REVISIONS			DATE
NO.	DESCRIPTION		
1	LOT 15 REVISIONS		03/16/21

KINGS FOREST
A RESUBDIVISION OF CARROLL/ZIEGLER PROPERTY NON-BUILDABLE BULK PARCEL K, AS SHOWN ON PLAT NO. 10791
CREATING LOTS 1-35, BUILDABLE PARCEL D AND NON-BUILDABLE PARCELS A, B, C, AND E THRU I

PROJECT: GRADING AND SEDIMENT EROSION CONTROL PLAN (PHASE I)

SITE PLAN FOR BAT INSTALLATION
PARCEL K (FUTURE LOT 15)
KINGS FOREST
LIBER 11372, FOLIO 431
PLAT NO. 19791
ELECTION DISTRICT No. 2
HOWARD COUNTY, MARYLAND
ADDRESS: 10500 PUDDING LANE
ELICOTT CITY, MARYLAND 21042

LOT 15
DISCONNECTION OF ROOFTOP RUNOFF (IN-1)
TO TOTAL

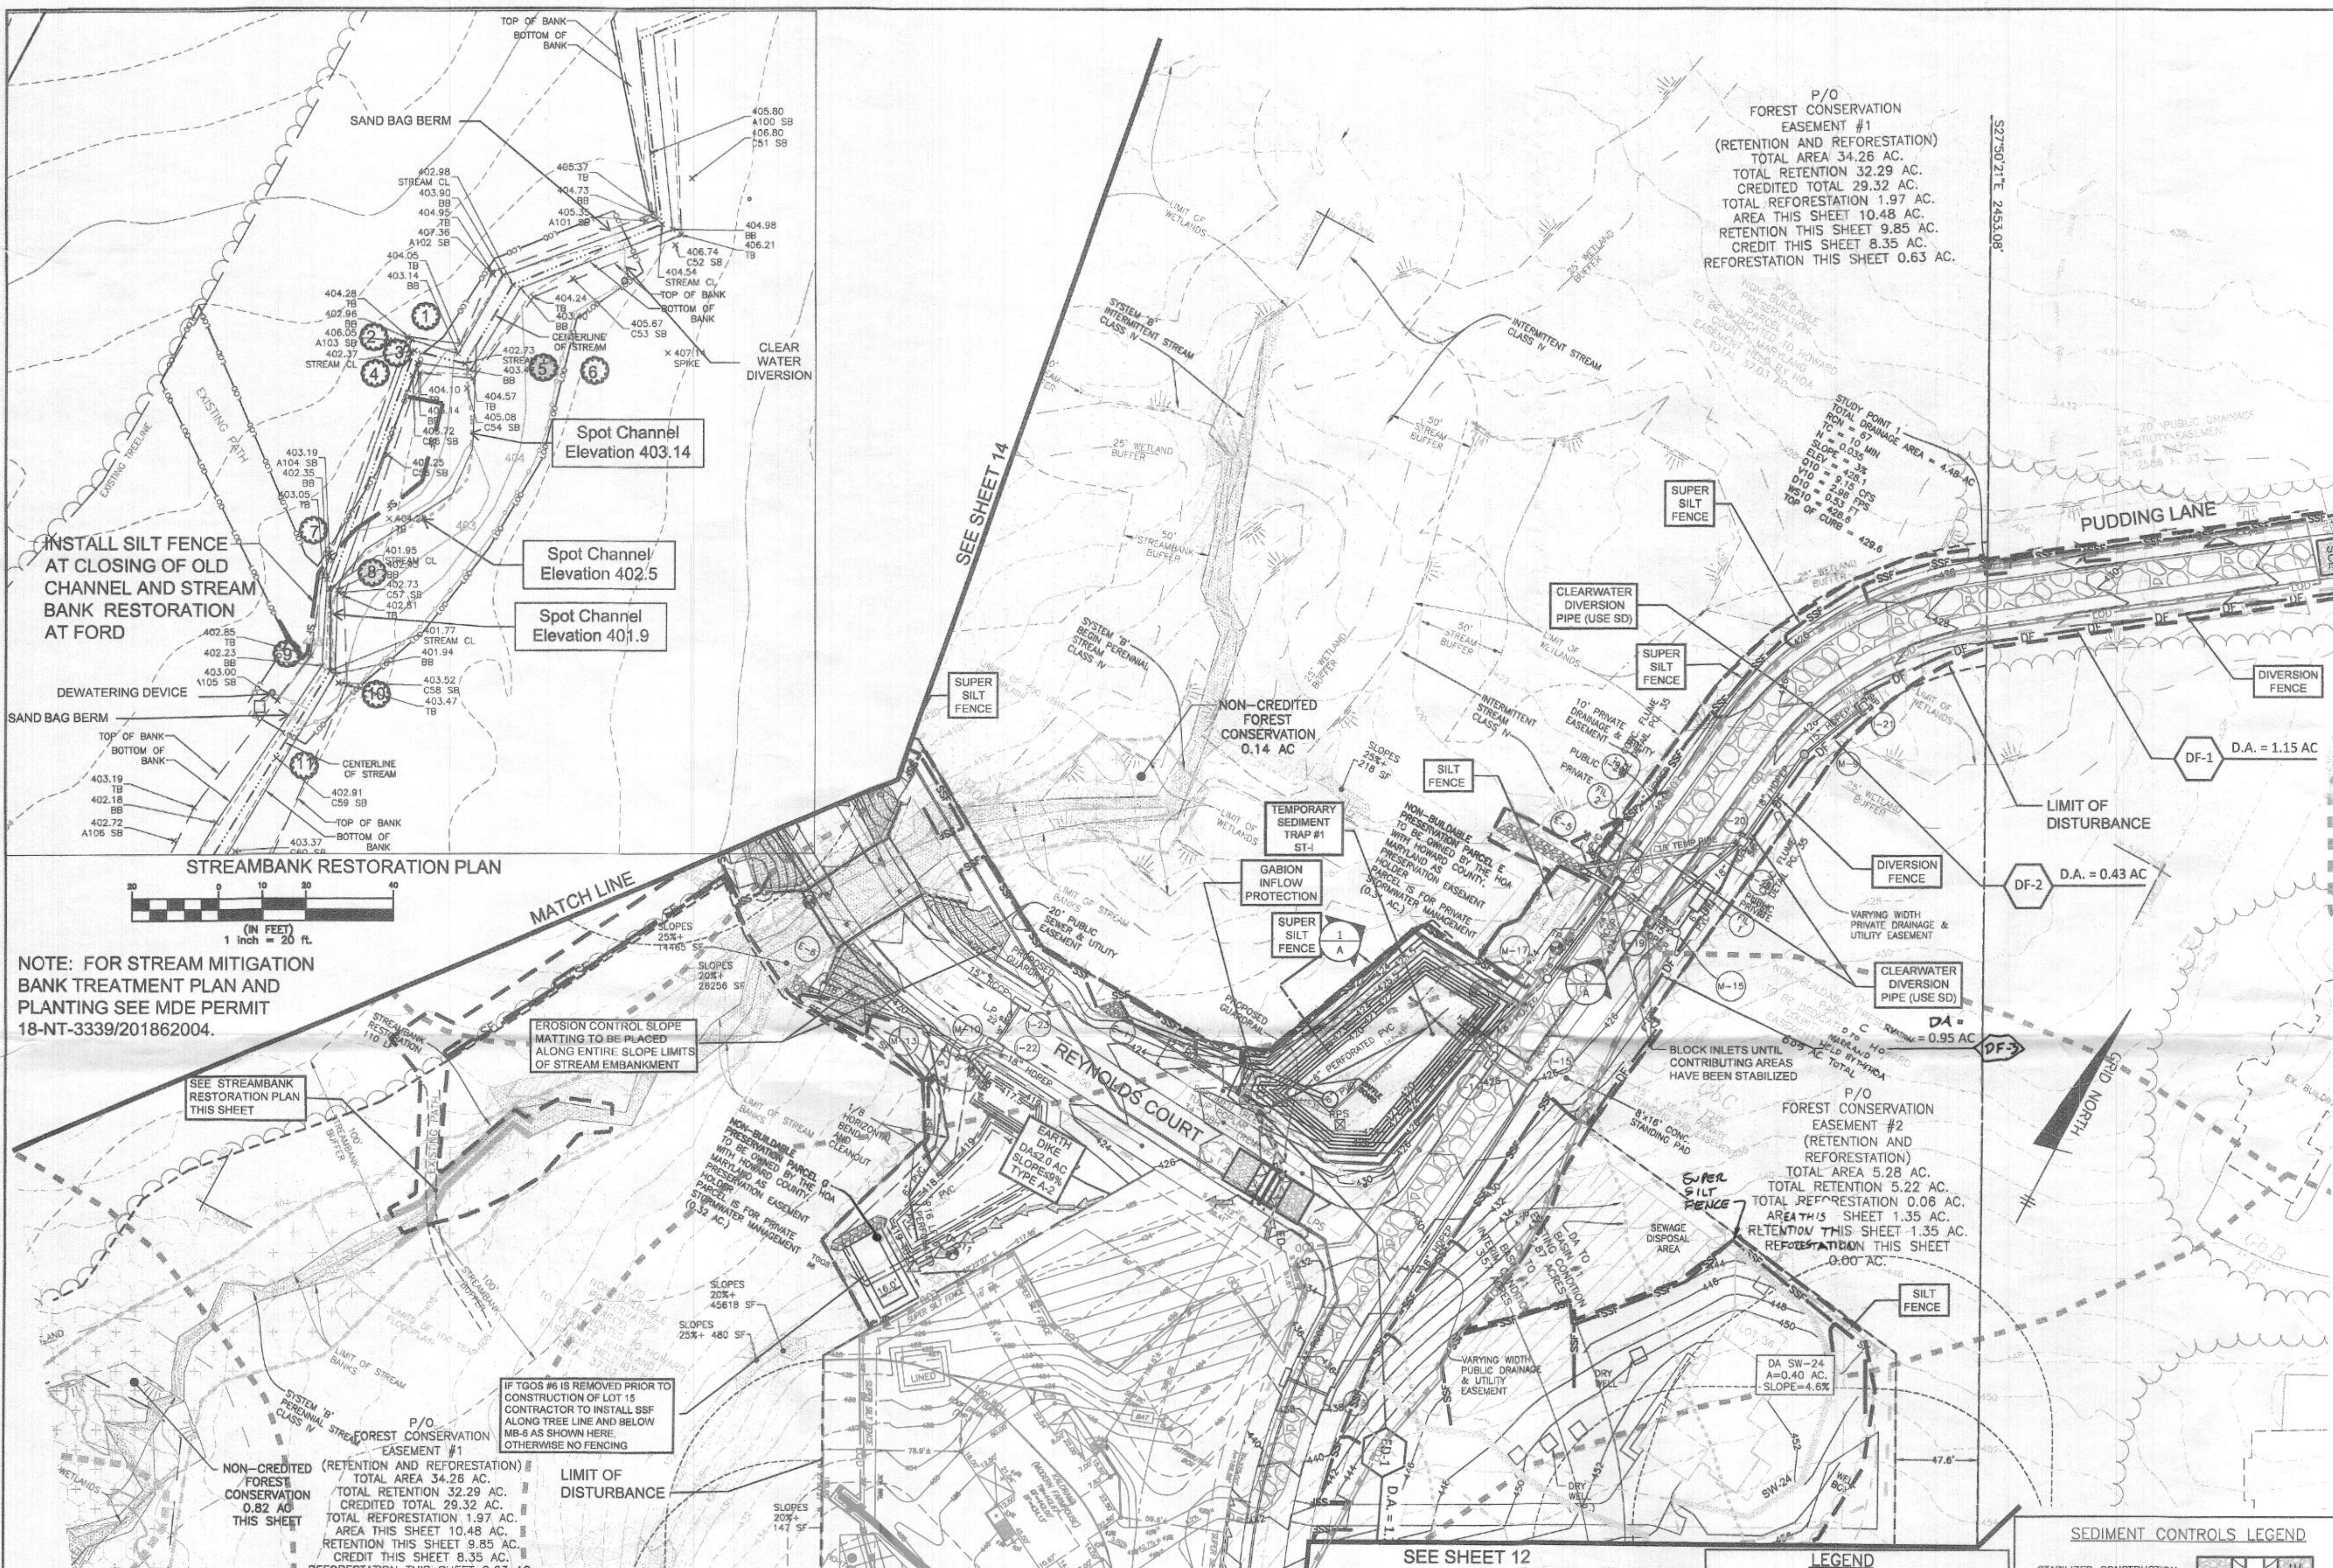
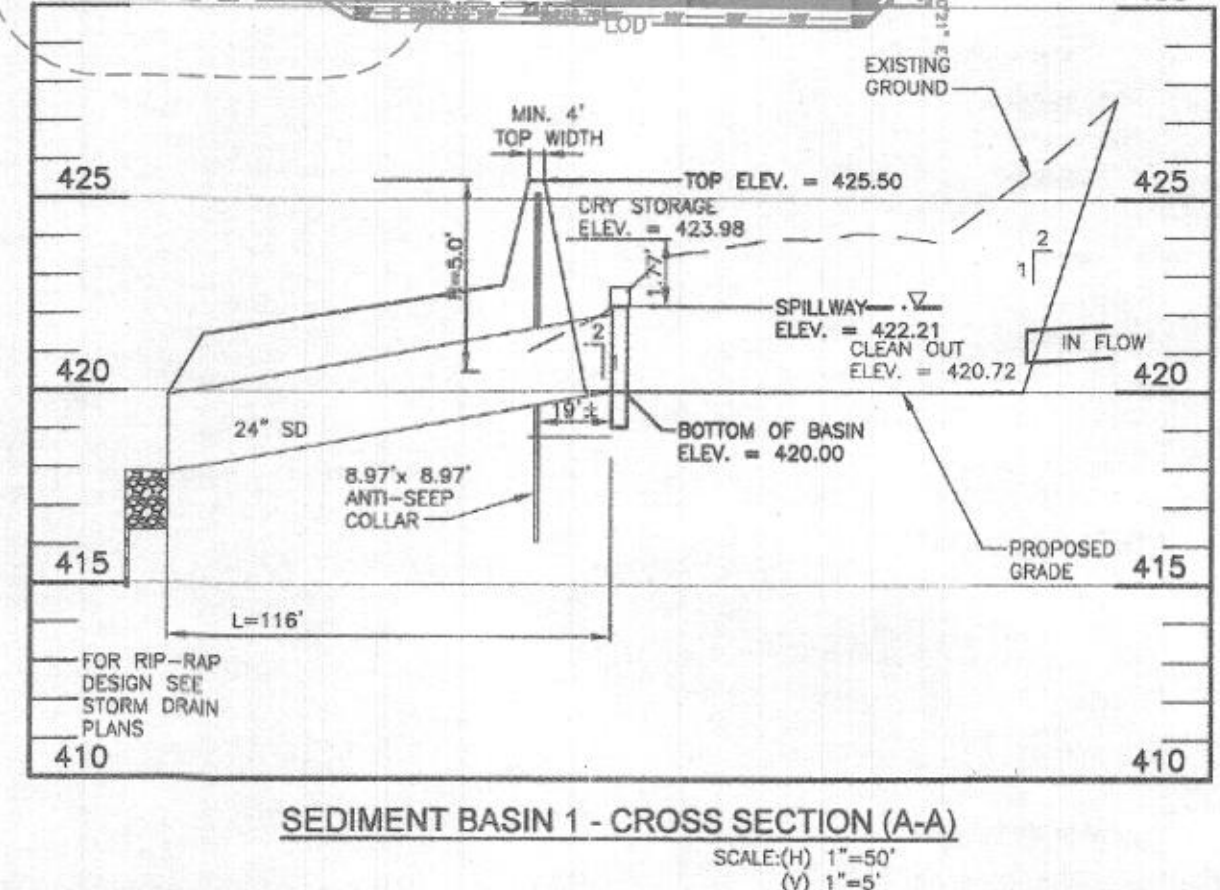
MICRO BIO-RETENTION (M-B)
5 ROOF DRAINS PIPED TO BIO
5 ROOF DRAINS SHEET FLOW TO BIO
20' (L) X 22'50' (W) X 1' (D)
TOTAL STORAGE 916 CF.
